ADDENDUM ONE

Project: **Sullivan County Immunization**

November 11, 2022

This Addendum is part of the Contract Documents for the above referenced project and modifies the original drawings and/or specifications, dated **10/27/22**, as noted below. The bidder shall acknowledge receipt of this Addendum in the place provided in the Bid Form. The published bid date and time shall remain the same.

TURNDOWN SLAB -DETAIL

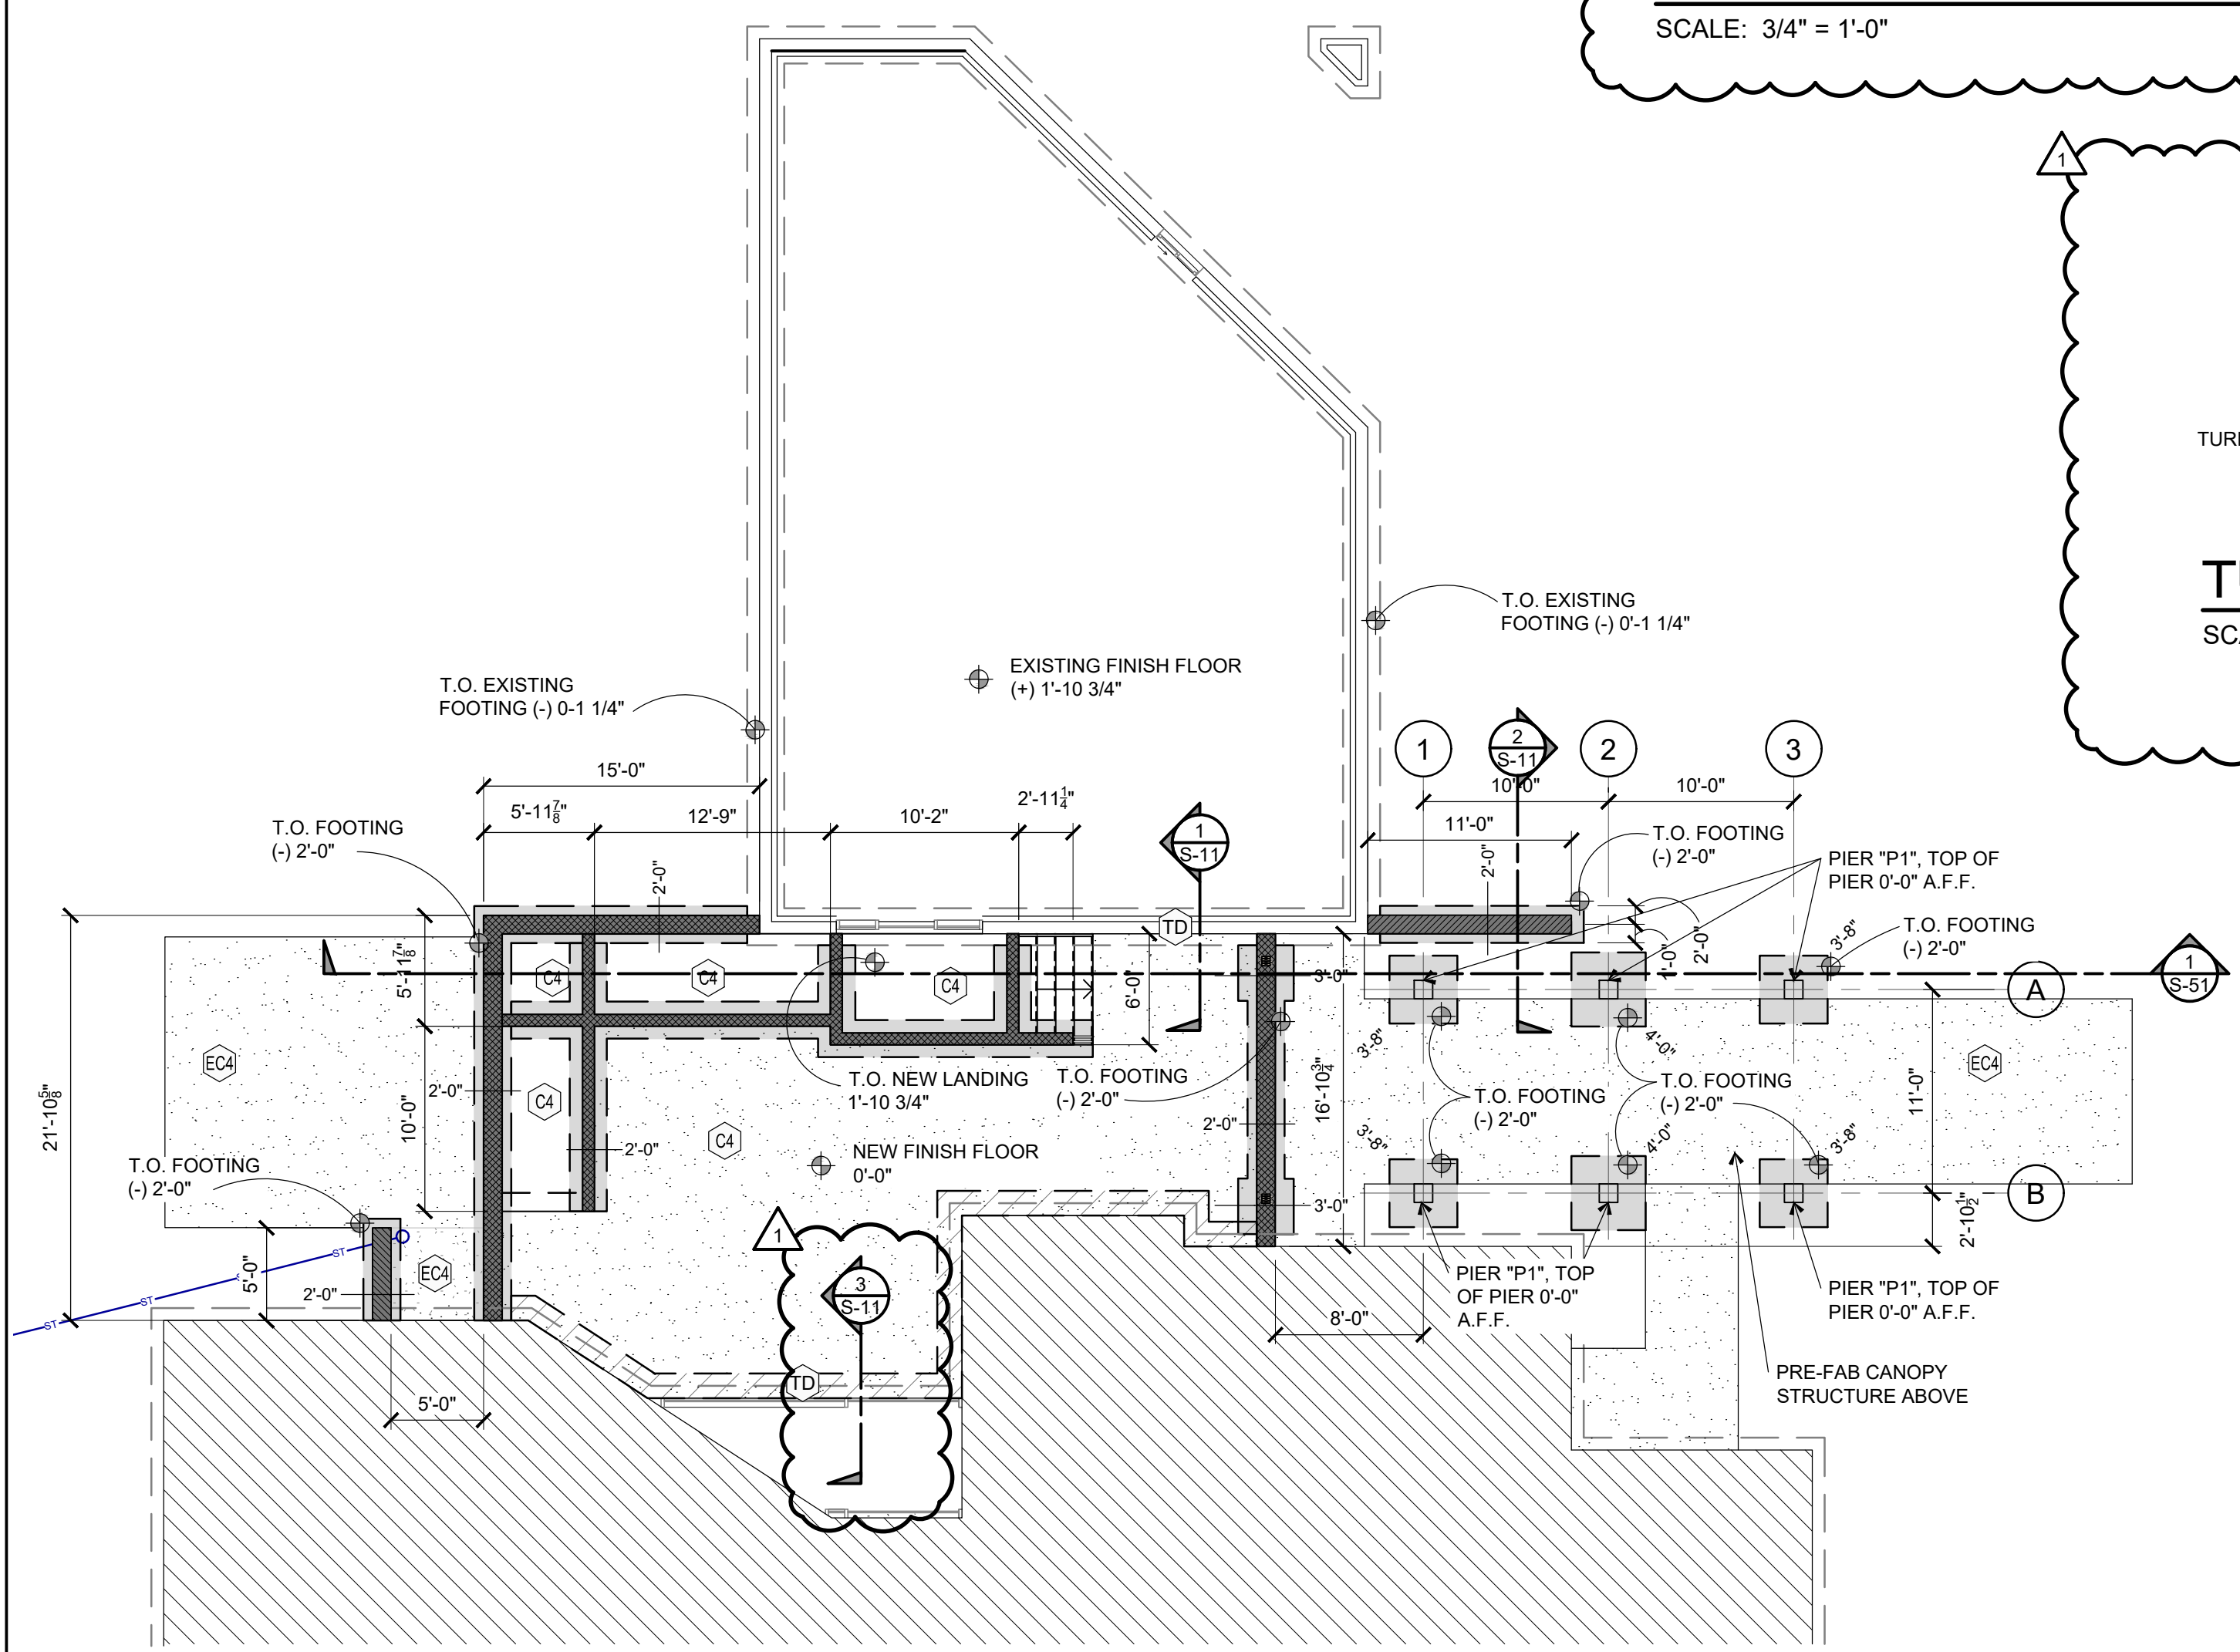
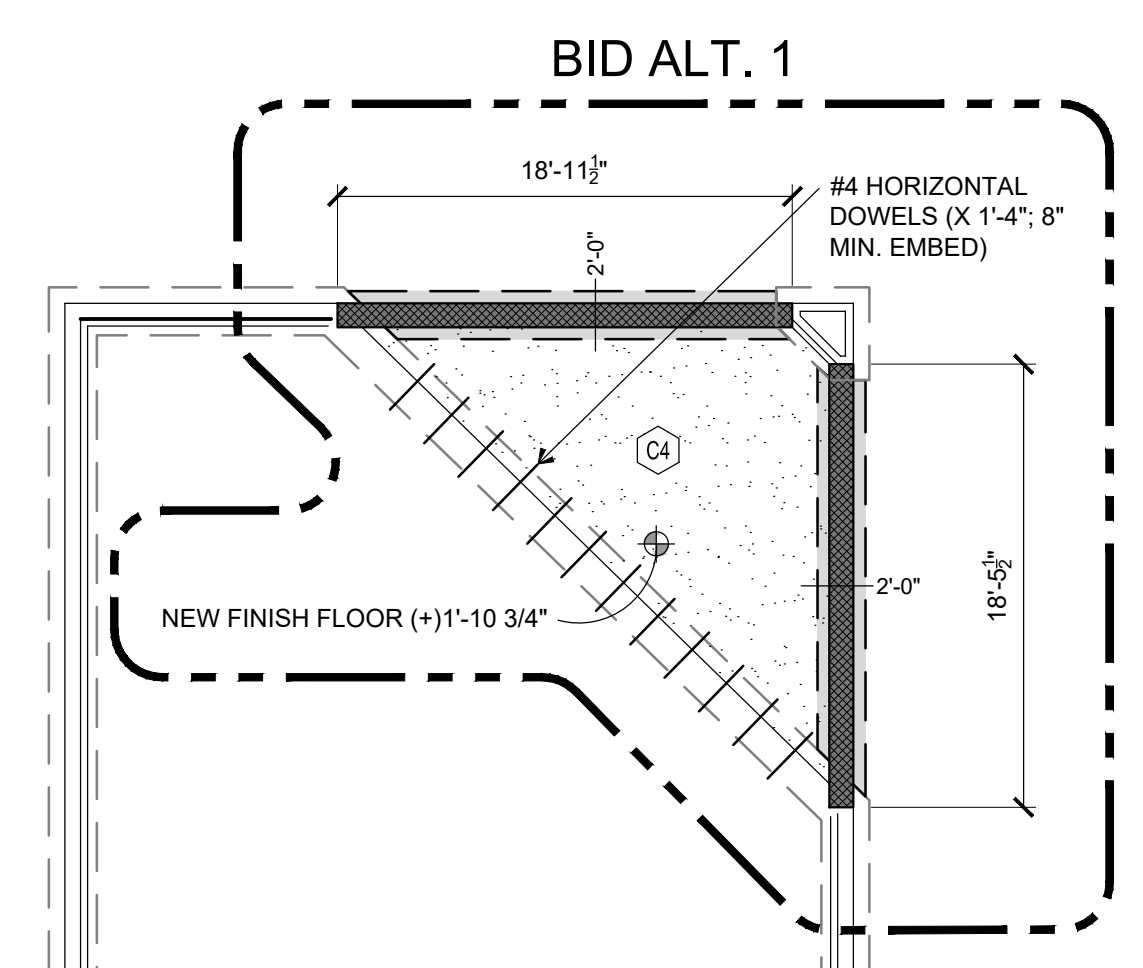
4. **Sheet C-51 Site Details** – clarification of notes.
5. **Sheet L-11 Landscape Plan** – change note 6.
6. **Sheet S-11 Foundation Plan** – add turn down slab detail.

ROOF FRAMING PLAN

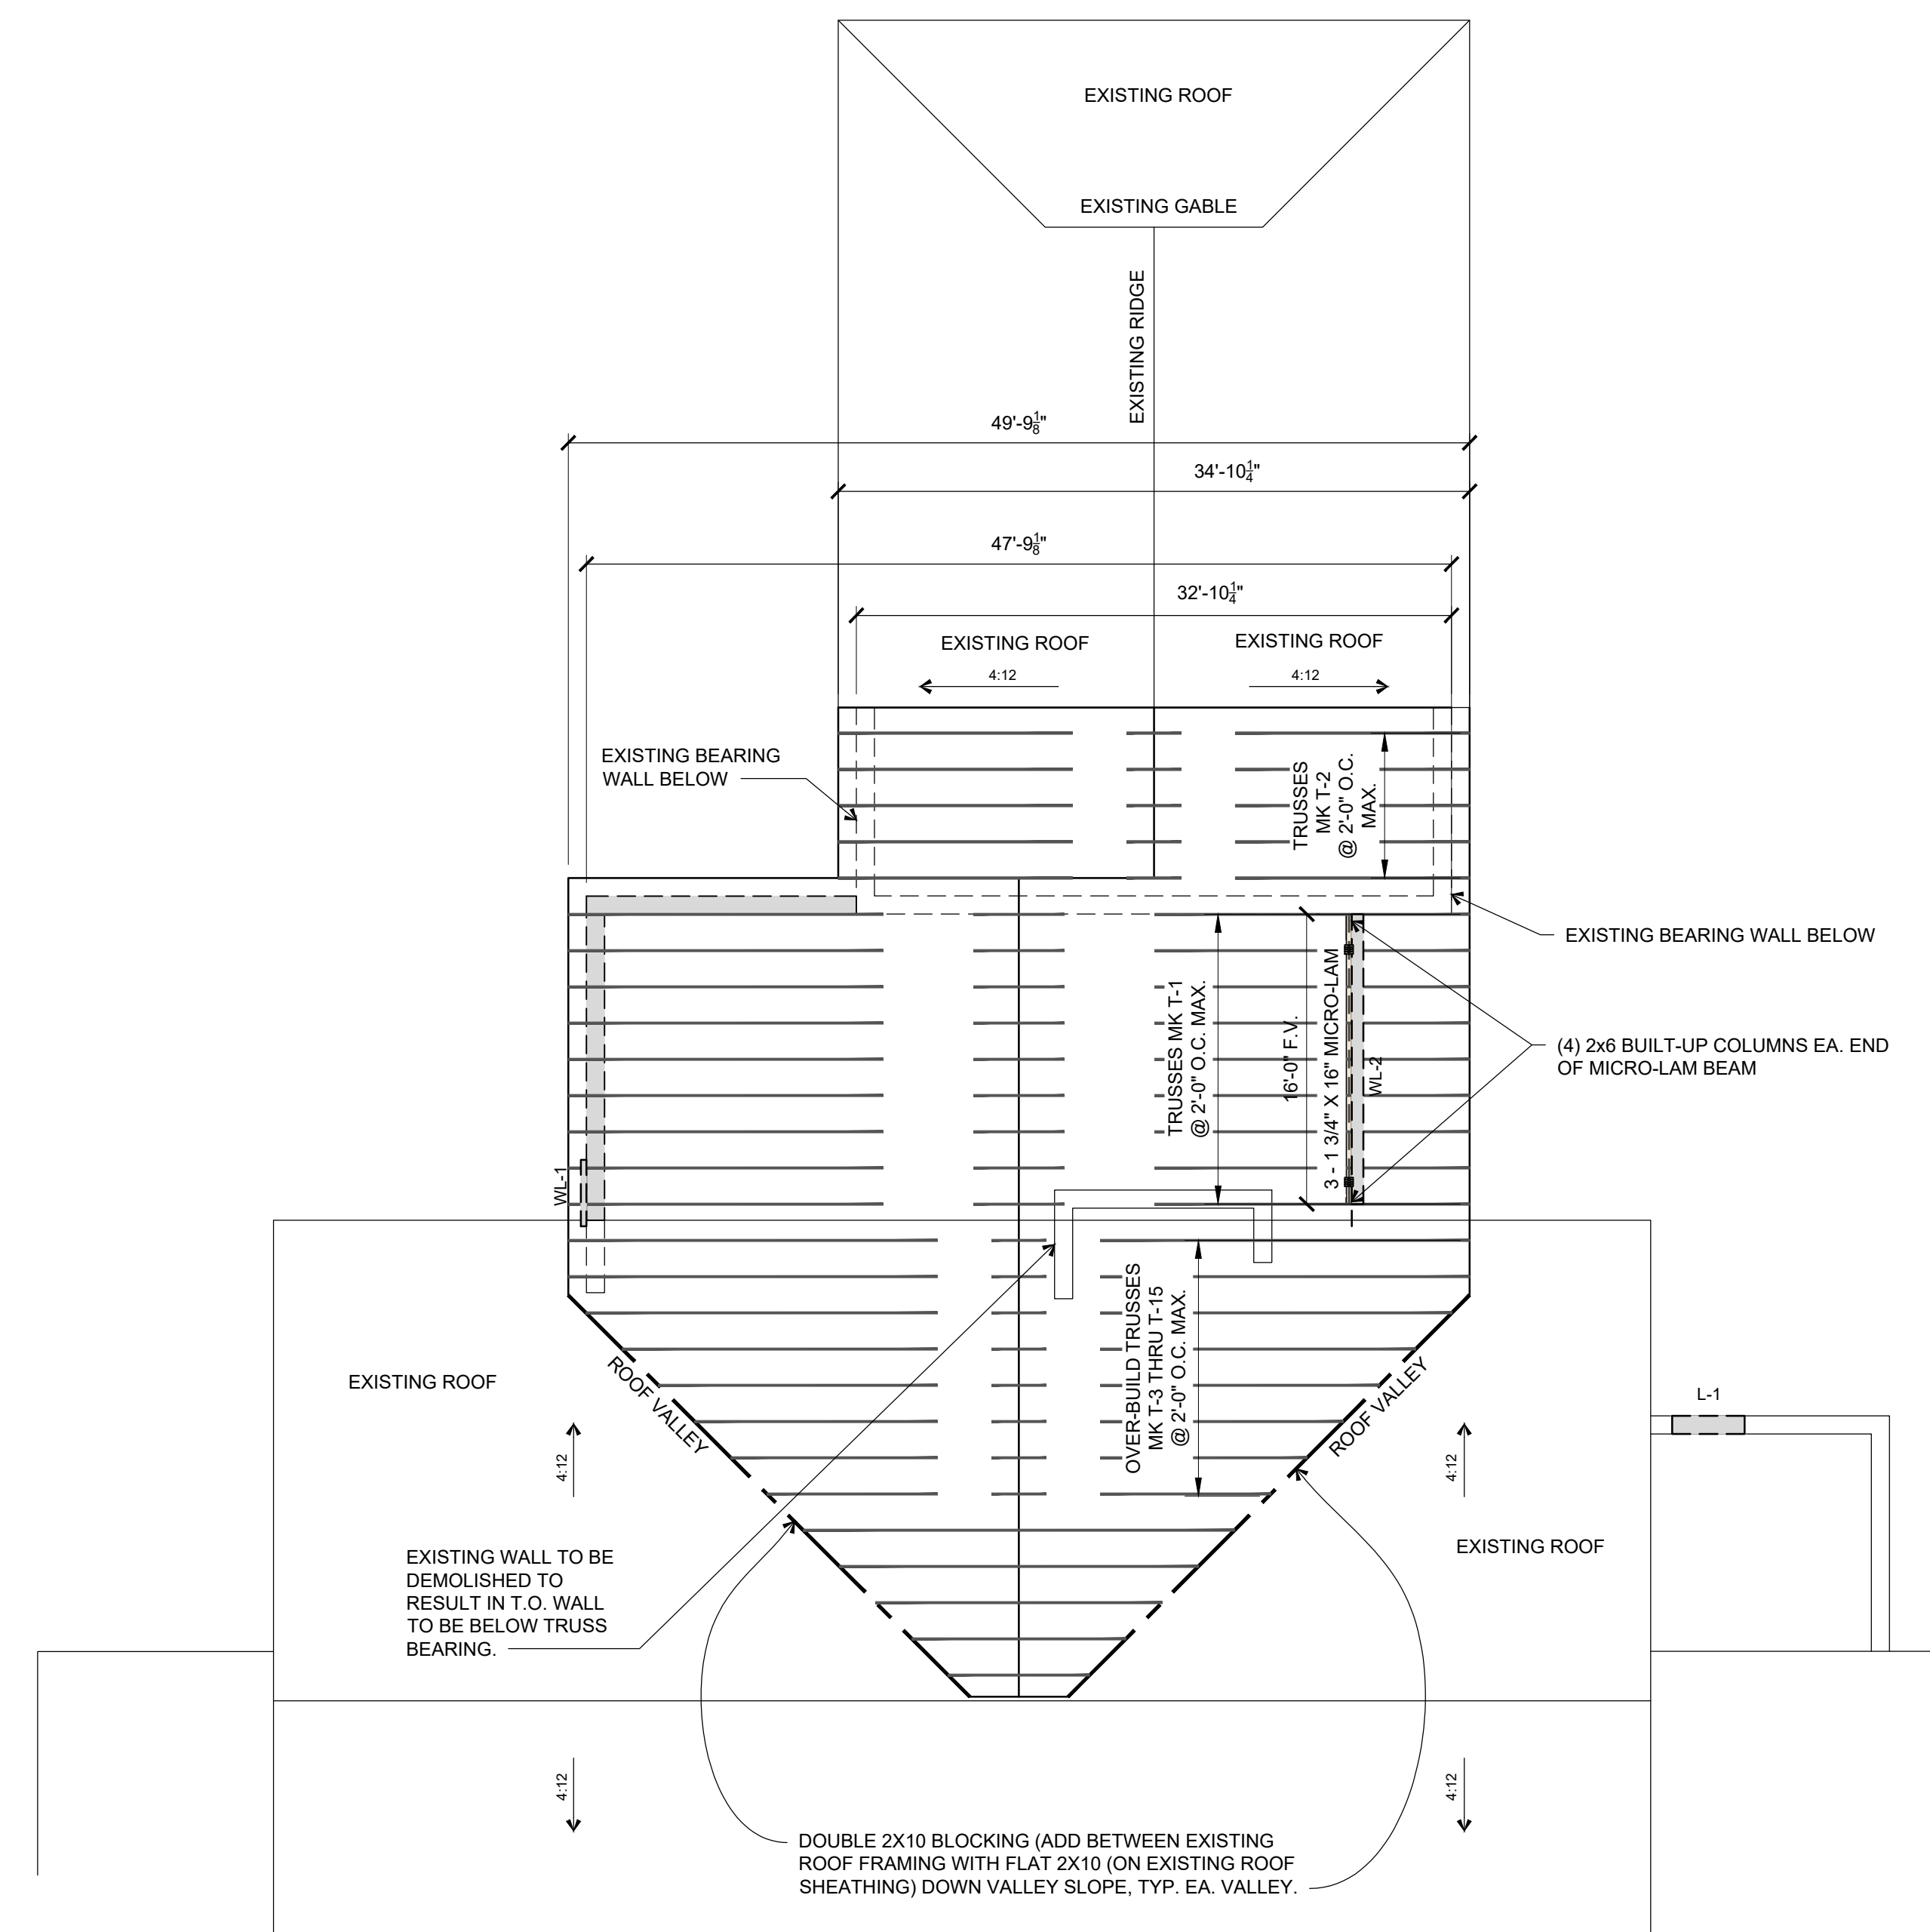
7. **Sheet S-15 Roof Framing Plan** – add lintel schedule.
8. **Sheet S-51 Structural Details** – change note “linear” to “legs”, change stair riser height.

LINTEL MK.	OPENING	MINIMUM BEARING LENGTH	LINTEL
WL-1	0" thru 6'-0"	N/A	Double 2x10 w/ 2x Top & Bot.
WL-2	6'-1" thru 8'-0"	N/A	Double 2x10 w/ 2x Top & Bot.
WL-3	8'-1" thru 10'-0"	N/A	Double 2x12 w/ 2x Top & Bot.
WL-4	10'-1" thru 12'-0"	N/A	Triple 2x12 w/ 2x Top & Bot.
WL-5	12'-1" thru 14'-0"	N/A	Triple 2x12 w/ 2x Top & Bot.
WL-6	14'-1" thru 18'-4"	N/A	Triple 2x12 w/ 2x Top & Bot.

Note: All Brick "Shelf" Angles / Lintels to be L5x5x $\frac{3}{8}$ (8" min. brng. each end)
